**Comments regarding**  
**Phased Final Map PID 9965**  
**3333 California Tentative subdivision map**

Map by: BKF Engineers

Dated: 6/12/2019

**C4.1**  
OF

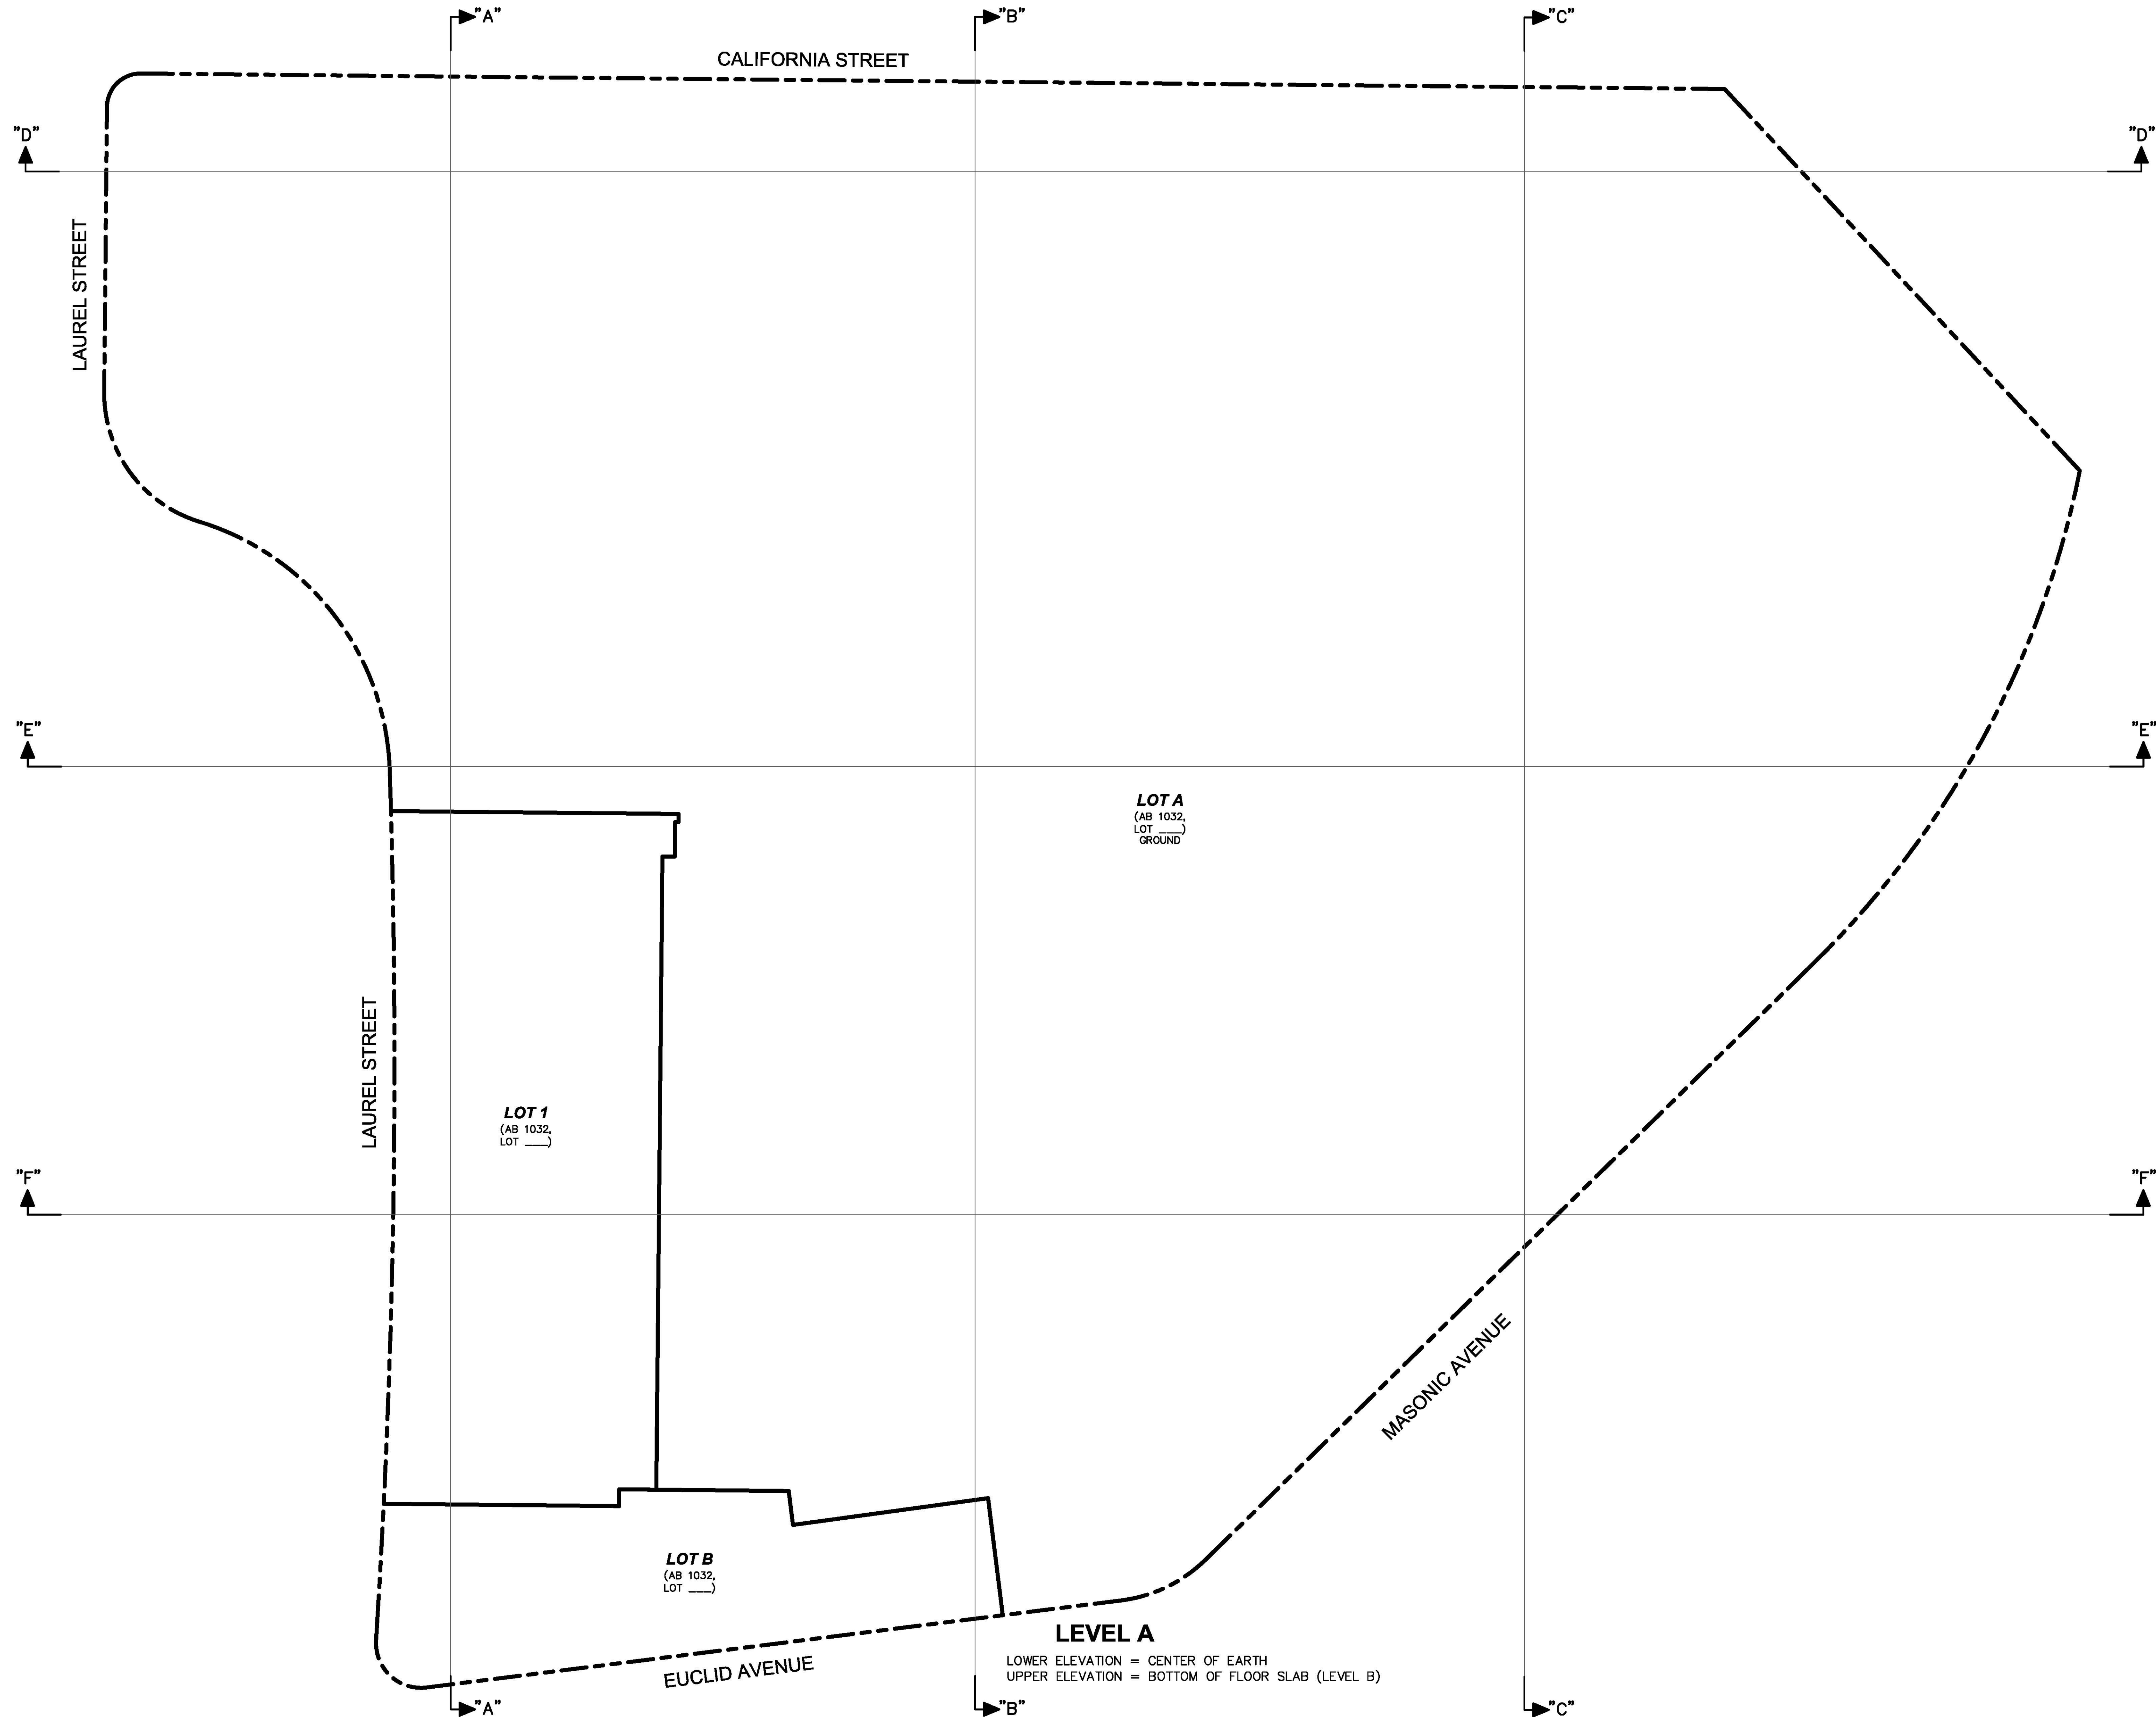
- Provide “bottom of the floor slab elevation (level B)”

**C4.3**

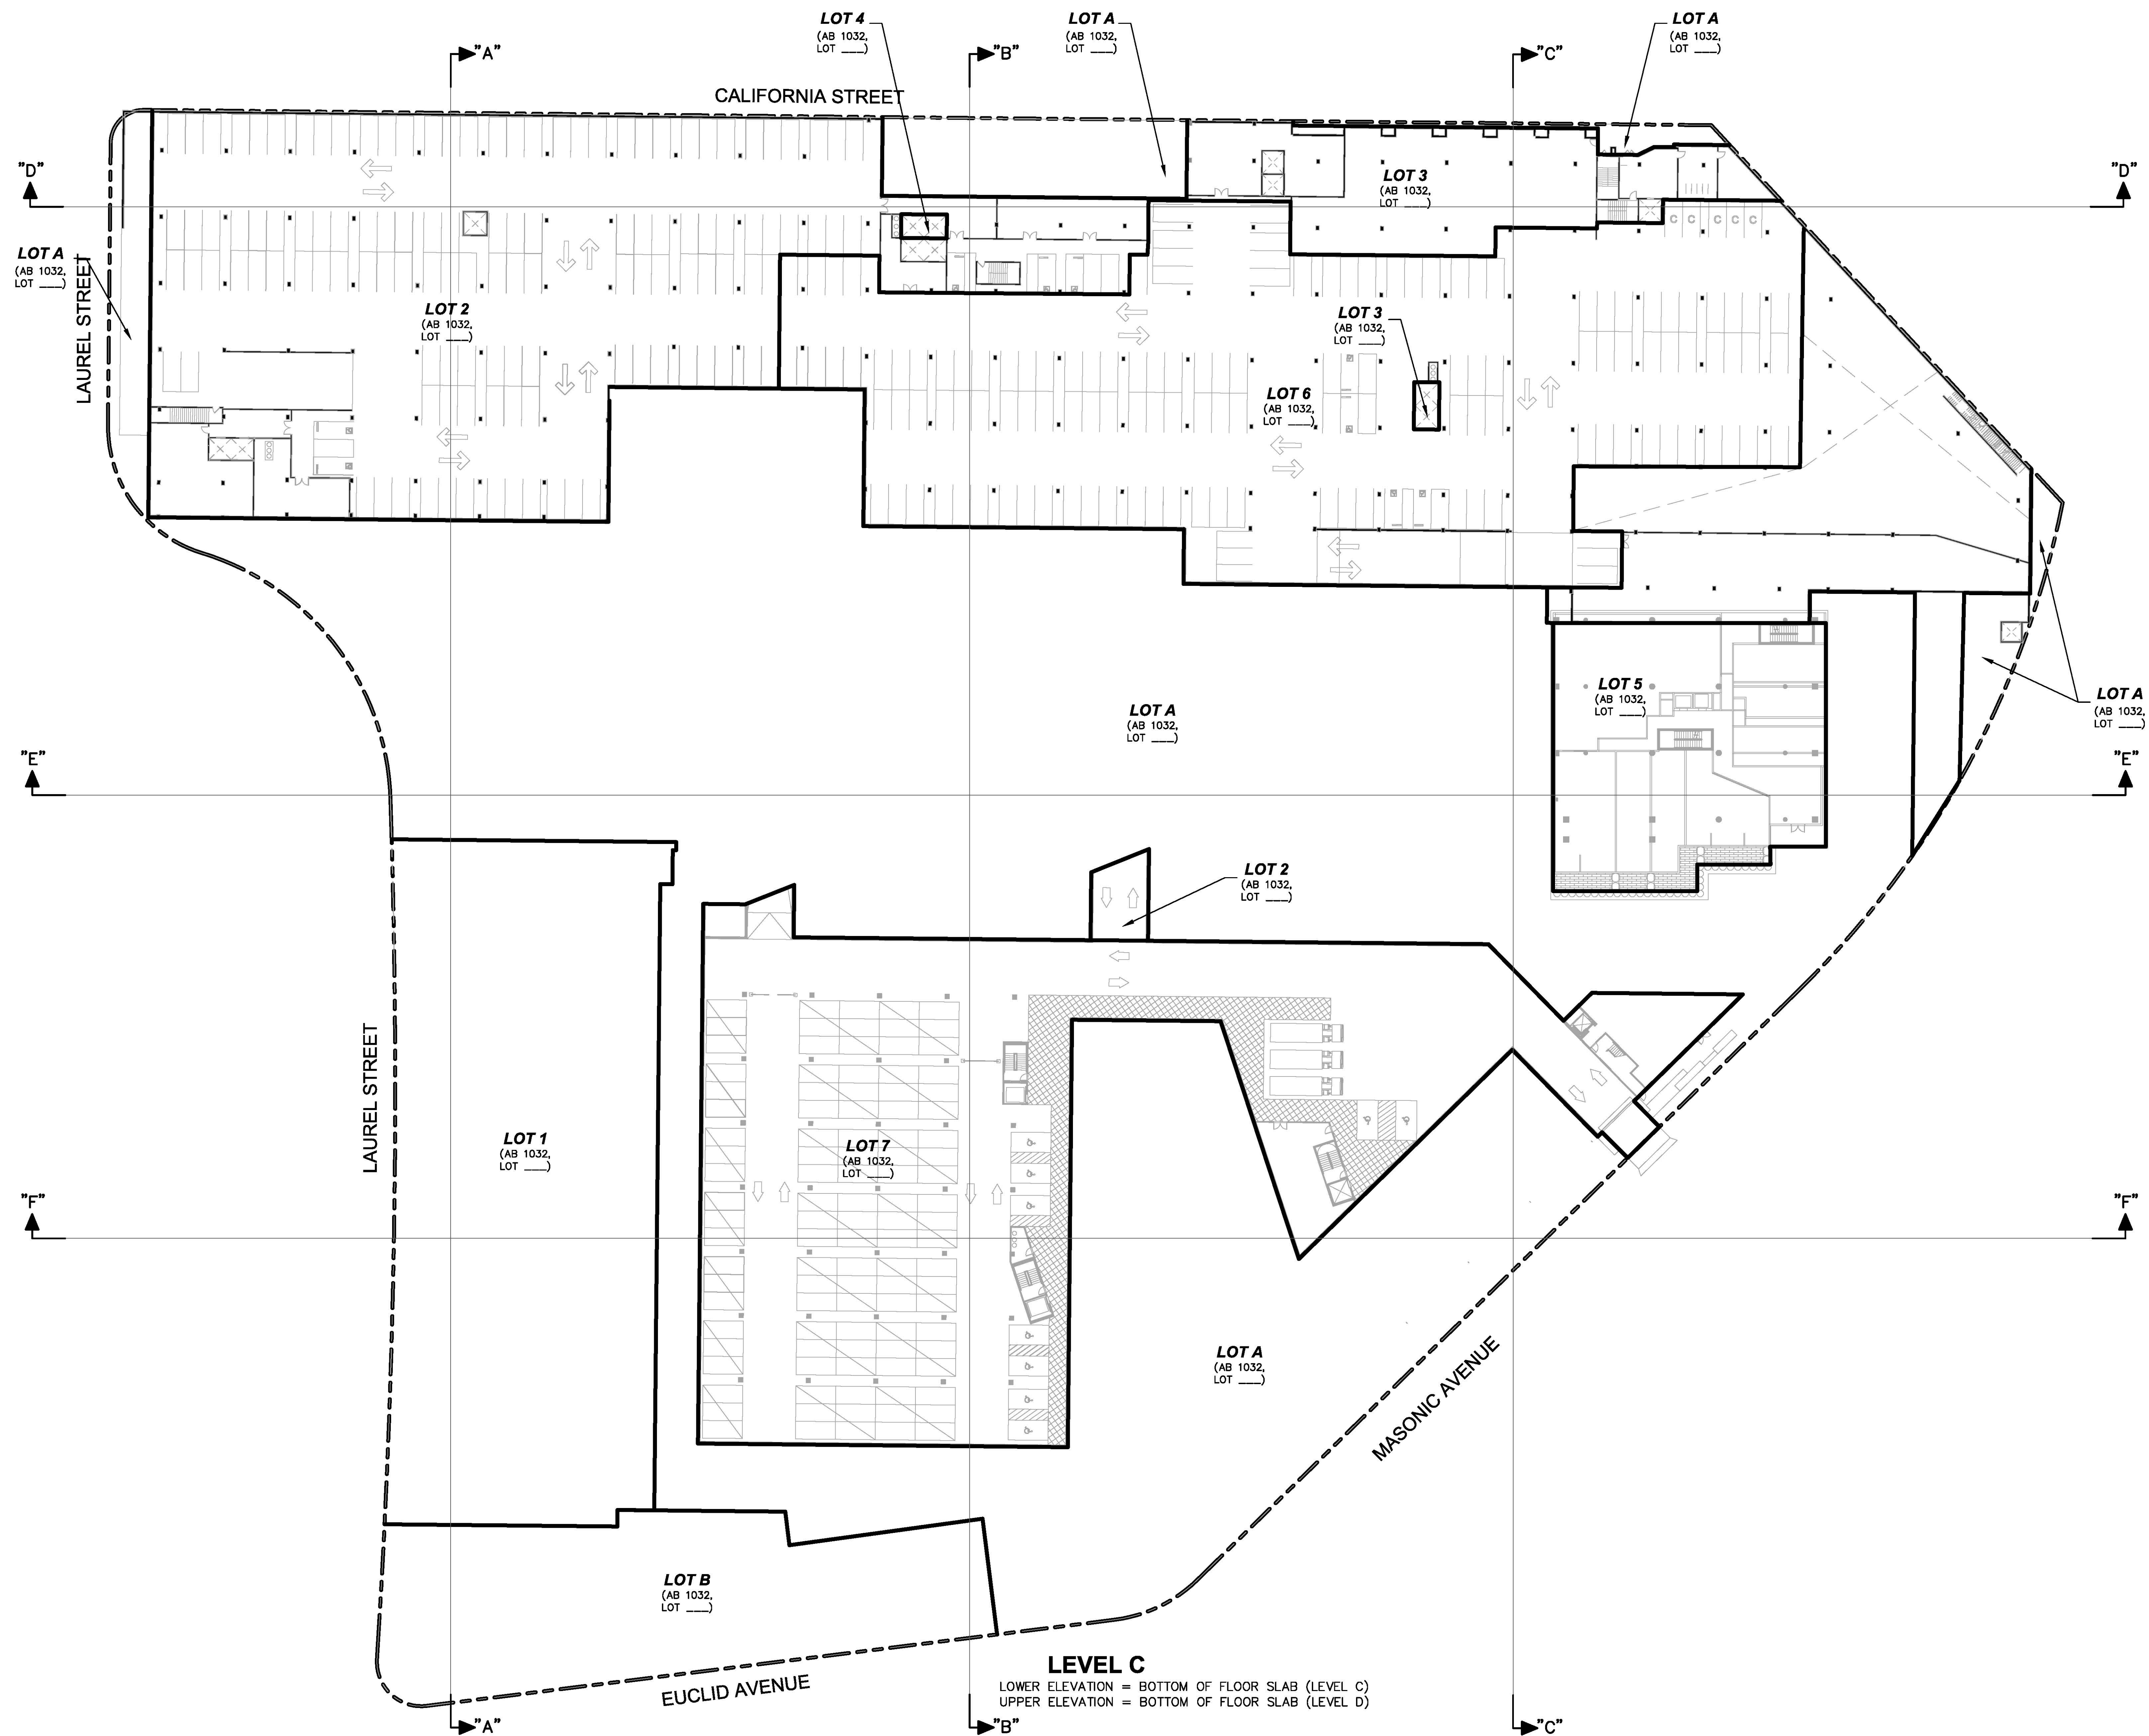
- Label lot 2 on the right side of the drawing (where section E-E passes through).
- See above comments

Drawing Number:  
**C4.5**  
OF

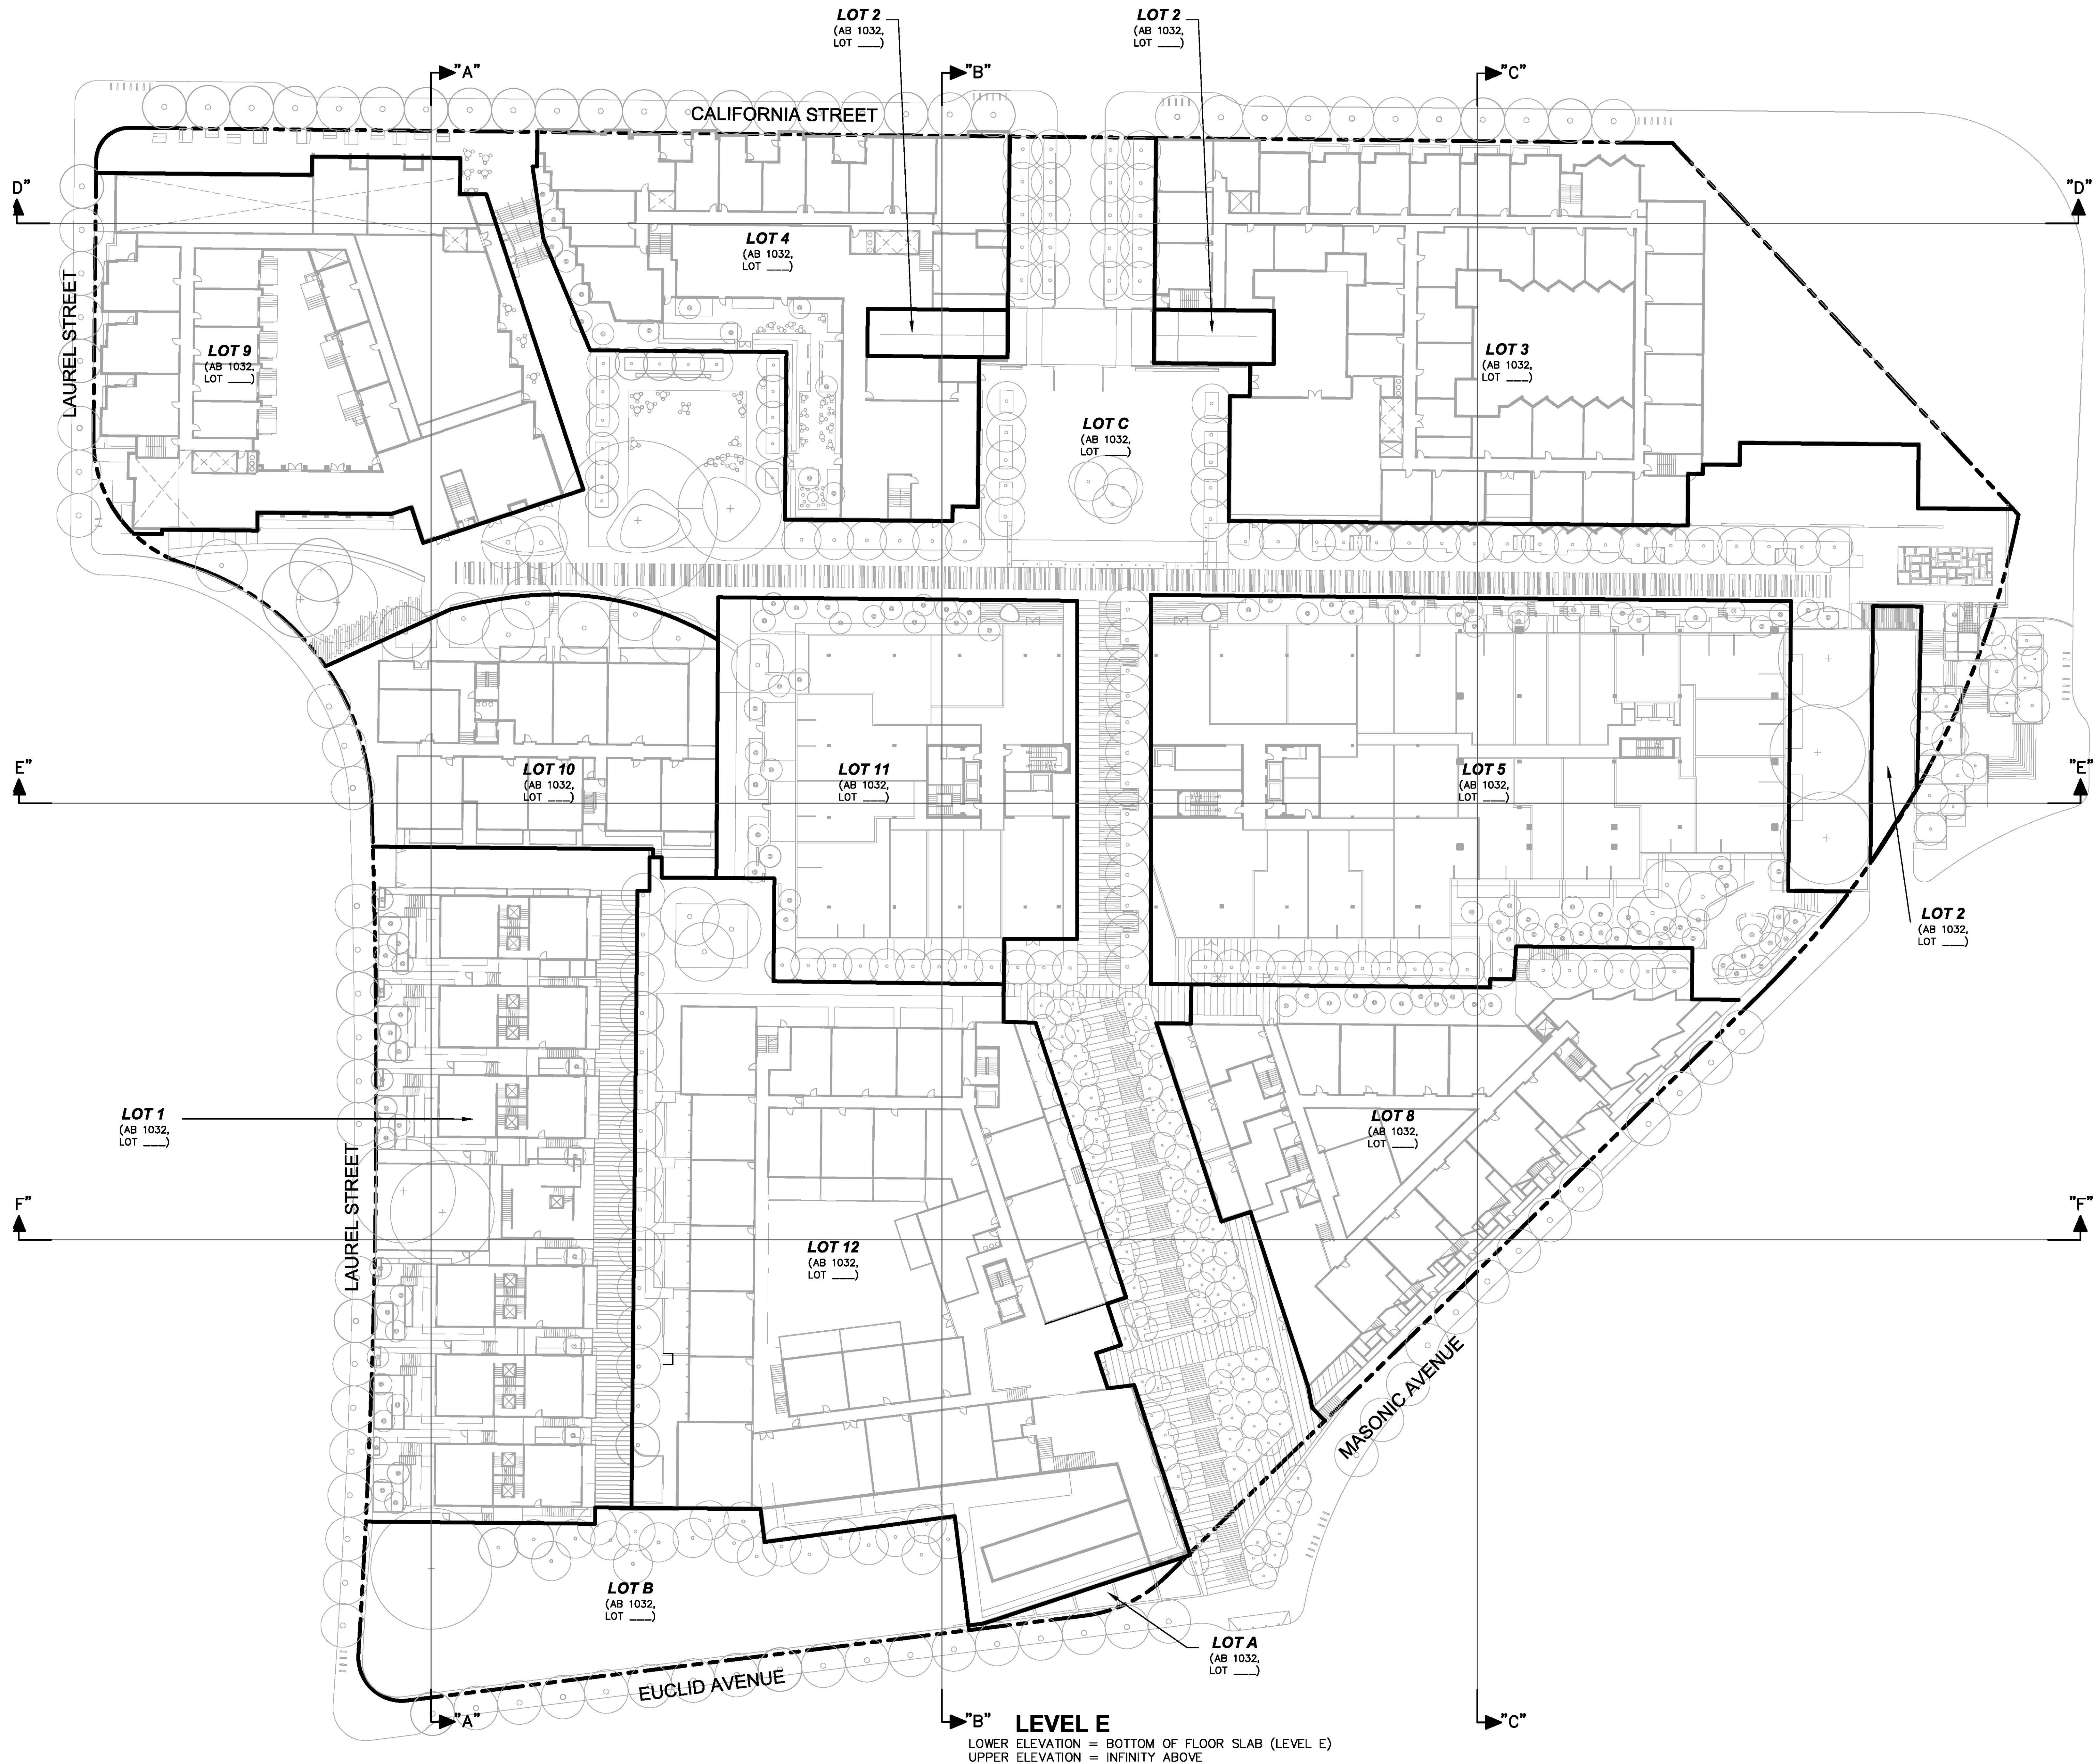
- Where is Lot C on the left side where section E-E passes through?
- See above comments
